VSP-33  
December 18, 1981

VENDOR SERVICE PUBLICATION

To: All Piper Distributors and CORPAC's  
Subject: Bendix Service Bulletins 611, 616, 617, 619

**Figure 1. Location of Drain Holes**

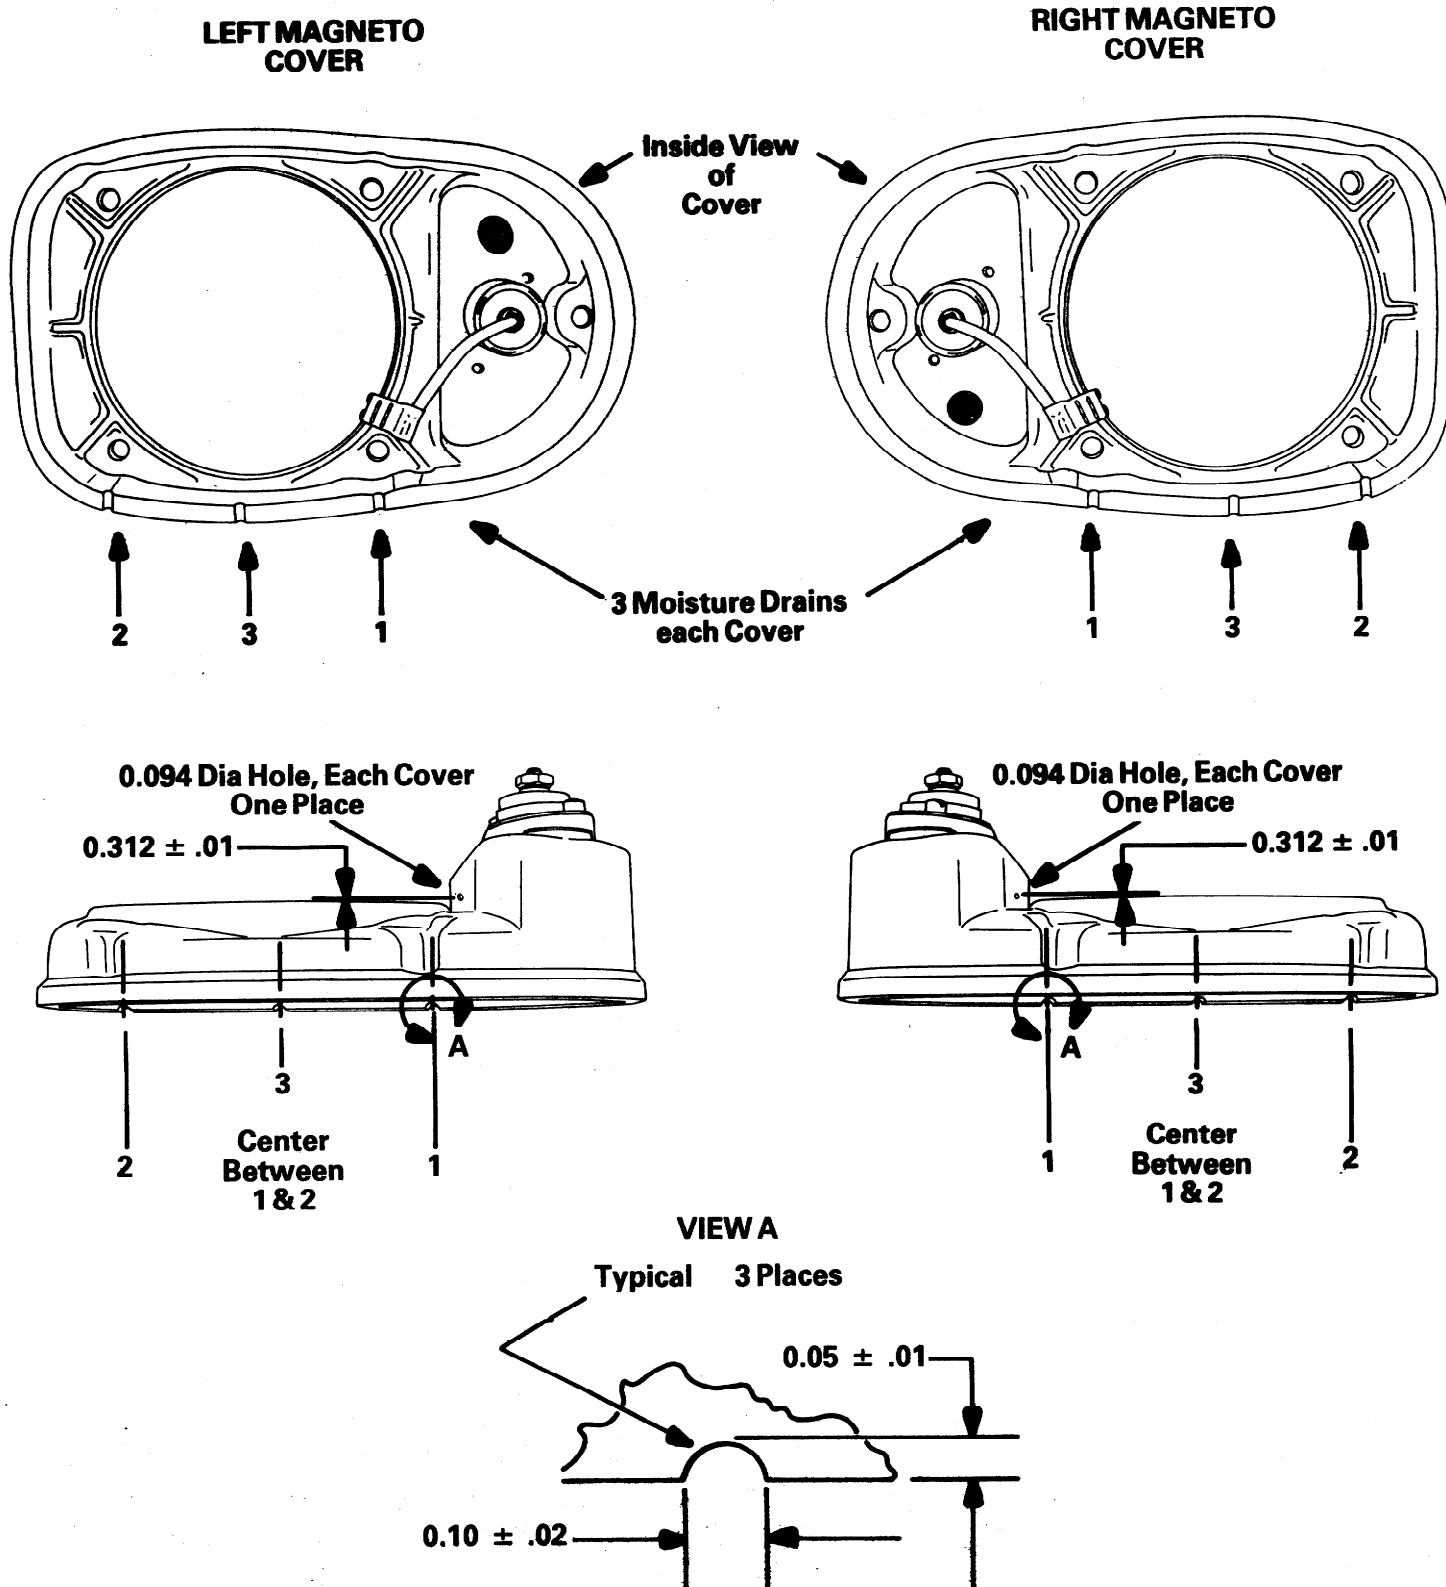
1. Remove the magneto cover by removing the ignition harness adapter plate from each magneto and then removing the magneto cover securing screw. Pull the magneto cover away from the magneto and carefully pull the capacitor, and retard lead, if used, from the breaker flag terminal(s).
2. Using Figure 1 as a guide, lay out the positions for the moisture drains. Positions 1 and 2 are in line with the stud holes in the cover and position 3 is centered between 1 and 2. Using a small round file, create the three hemispherical recesses as detailed in view A, figure 1.

3. Lay out the position for drilling a 0.094 in.  $\pm$  0.005 in. hole in the center of the ledge area of the covers and drill one hole in each cover using a 3/32" or No. 42 drill, as shown in Figure 1.

Do not allow the drill to penetrate through the cover and hit the housing of the capacitor which is directly in line with the hole being drilled. Mask drill bit for maximum allowable depth (1/4 in.).

The moisture drains must be on the lower side of each cover when it is reinstalled on its related magneto assembly on the engine.

4. Remove any burrs left during the filing and drilling operations on the covers and clean the covers of any metal shavings. Apply a thin coat of black enamel to the bare metal exposed during the filing of the moisture drains. Avoid getting paint on the adjacent cover-to-magneto mounting surface.

5. With a putty knife, spatula or similar tool, apply a sufficient amount of sealant to the outside of the vent screen to fill the vent screen recess flush with the adjacent cover surface. Acceptable sealants are listed below:
  - a. Dow Corning Sealant No. 3145
  - b. Permatex No. 1
  - c. Hi-Sol Epoxy Patch, Kit 1C
  - d. G.E. Silicone Sealant (Automotive type)

Figure 1. Exploded View

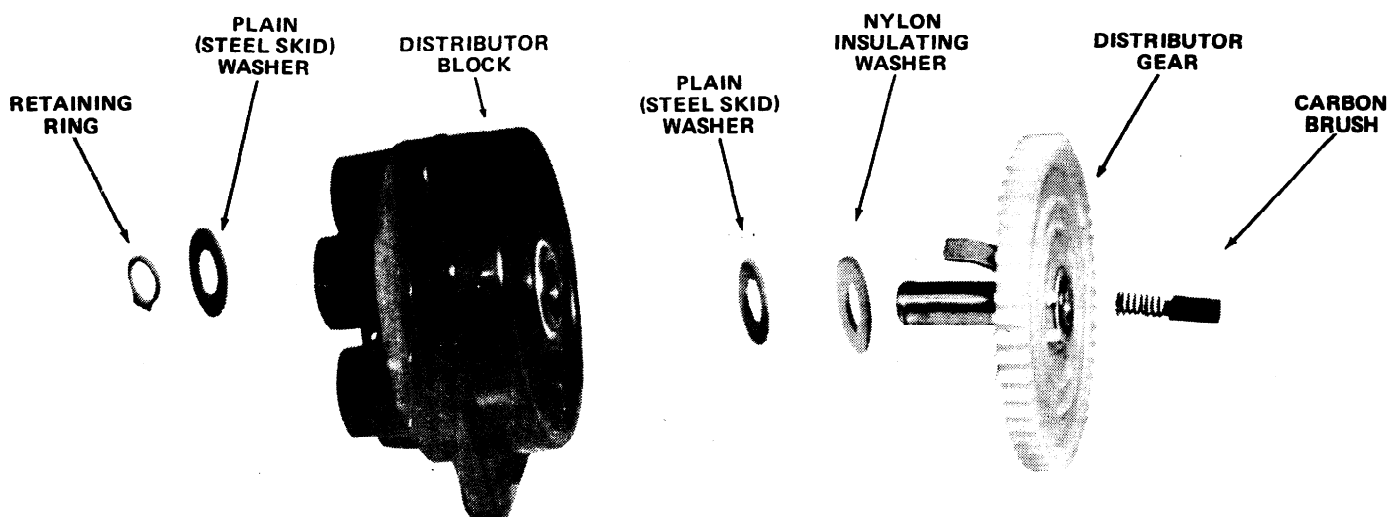
The 10-357584 and 10-357586 Insulated Distributor Gear Kits for S-20 and S-200 Series Magnetos are being provided as a standardization change for Bendix magnetos. With the introduction of these kits, all new Bendix aircraft magnetos delivered from the factory will be provided with insulated distributor gears. The insulated gear kits include all parts (except distributor block) as identified in figure 1.

Assembly sequence of the gear kit to distributor block is shown in the exploded view of figure 1.

Figure 1. Location of "x" on Identification Plate

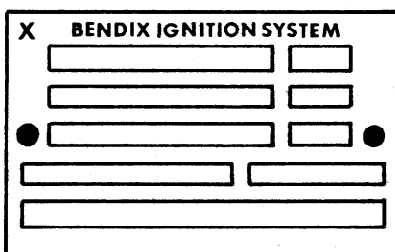
All D-2000/2200 series magnetos below serial number 35480 (red label magnetos) and below serial number 8122106 (blue label magnetos) unless identified with an "x" in the upper left corner of the identification plate before the word "Bendix" (see figure 1). The "x" on the identification plate indicates previous compliance.

6. If new serviceable gears, identified with the "z", the "x" and "o", or the "L" are installed in the magneto, identify the magneto by stamping the letter "x" in the upper left corner of the identification plate, before the word "Bendix" (see figure 1).

Figure 2. Location of Identification Mark(s)  
on Distributor Gear

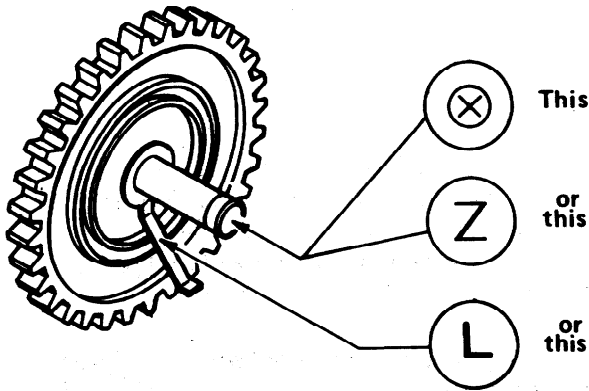
hours or at the next regularly scheduled inspection, whichever occurs first, and reinspected every 100 operating hours until the magneto has 500 operating hours. If the gears fail the inspection they must be replaced immediately with new, serviceable gears; if they pass each inspection they may remain in service until magneto overhaul, at which time they must be replaced with new, serviceable gears. At owner's option, gears that pass inspection may be replaced at any time during the compliance period with new, serviceable gears as identified in this paragraph and figure 2. Serviceable gears are identified by the presence of the letter "z" or the letters "x" and "o" appearing together, laser etched on the retaining ring end of the gear axle, or the letter "L" stamped on the electrode (see figure 2).

1. Remove cover from magneto and inspect the retaining ring end of the distributor gear axles for the letter "z" or the letters "x" and "o". (The letter "x" may or may not be circled by the letter "o".) If the letter "z" or the letters "x" and "o" together are laser etched on the end of the axles, the gears are serviceable and the cover can be reinstalled. Identify the magneto per

Figure 3. Checking for Loose Electrode

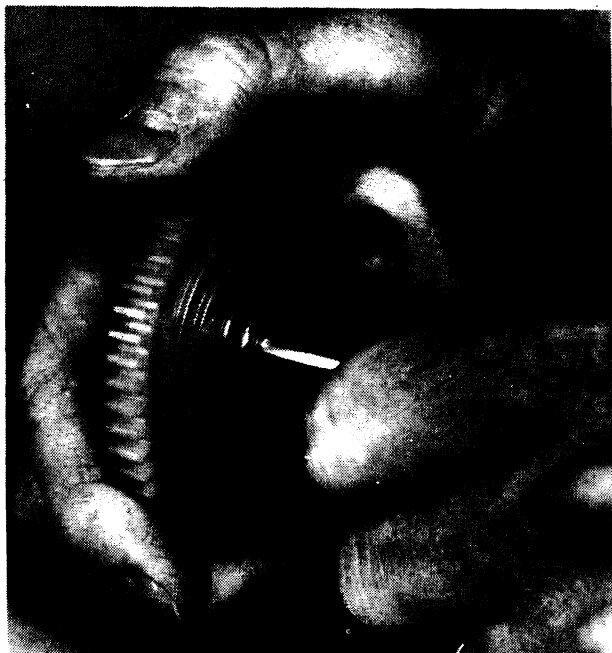
5. If the gear is the uninsulated type (no nylon washer) inspect the gear for a loose electrode. Grasp the gear firmly in one hand and alternately exert clockwise and counterclockwise force against the electrode with maximum hand pressure. This should be done in a manner that would attempt to pivot the electrode around the axle (see figure 3). If any movement is detected between the electrode and the gear, the gear must be discarded and replaced with a new, serviceable gear.

Figure 1. Location of "x" on Identification Plate

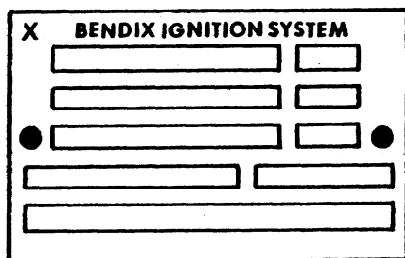
All D-3000/3200 Series (blue) Magnetos with Serial Numbers 100 through 1968 not identified by the letter "x" in the upper left corner of the identification plate (see figure 1). The "x" on the identification plate indicates previous compliance.

7. After the magneto has been reassembled with new serviceable gears, identify the magneto by stamping the letter "x" in the upper left corner of the identification plate, before the word "Bendix" (see figure 1).

Figure 2. Location of Identification Mark(s)  
on Distributor Gear

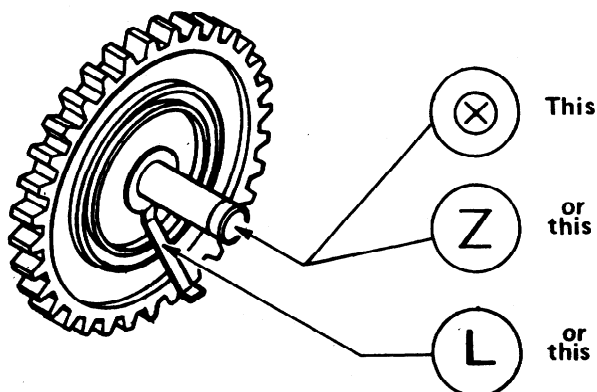
All distributor gear kits P/N 10-682014 and P/N 10-682016 which contain gears that are not identified by the presence of the letter "z" or the letters "x" and "o" together, laser etched on the retaining ring end of the gear axle, or the letter "L" stamped on the electrode (see figure 2).

5. Reassemble the distributor block with new serviceable gears. Serviceable gears are identified by the presence of the letter "z" or the letters "x" and "o" together, laser etched on the retaining ring end of the gear axle, or the letter "L" stamped on the electrode (see figure 2).
